|  Tesla, Inc. Service Bulletin | | <h2>Replace Front Fascia Harness and Front Fascia Camera</h2> | |
| SB-25-17-012 February 18, 2026 | | | |
| Model Y | 2025+ | North America | Fremont, Giga Texas |

Figure 2: Water inside of camera

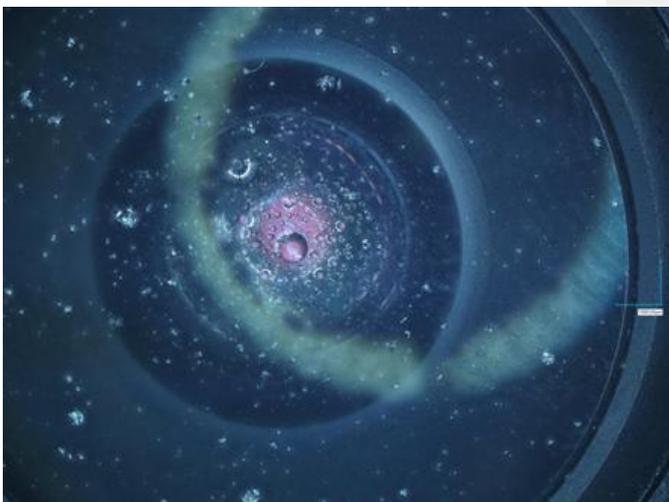
3. Remove the front fascia camera (refer to Service Manual procedure [1722010011](#)).
4. Use an LED flashlight to inspect the front fascia camera lens and connector for any signs of water ingress or corrosion (Figures 2 and 3).
 - If any signs of water ingress or corrosion are present, replace both the front fascia camera and the front fascia harness (refer to Service Manual procedures [1722010012](#) and [1710040202](#)), then skip to step 11.
 - If no signs of water ingress or corrosion are present, proceed to step 5.

Figure 8

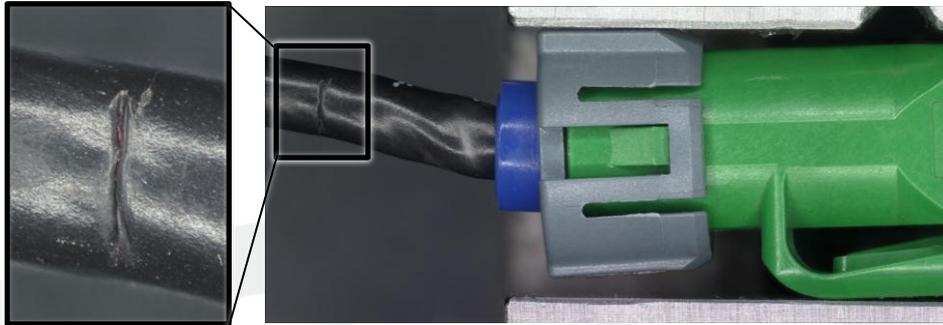
8. Inspect the harness for signs of abrasion or water ingress (Figures 8 – 11).

- If any signs of abrasion or water ingress are present, replace both the front fascia camera and front fascia harness (refer to Service Manual procedures [1722010012](#) and [1710040202](#)), then skip to step 11.
- If no damage or water ingress is present on the harness, reinstall the corrugated tubing onto the harness and wrap the end of the tube near the camera connector with electrical tape.
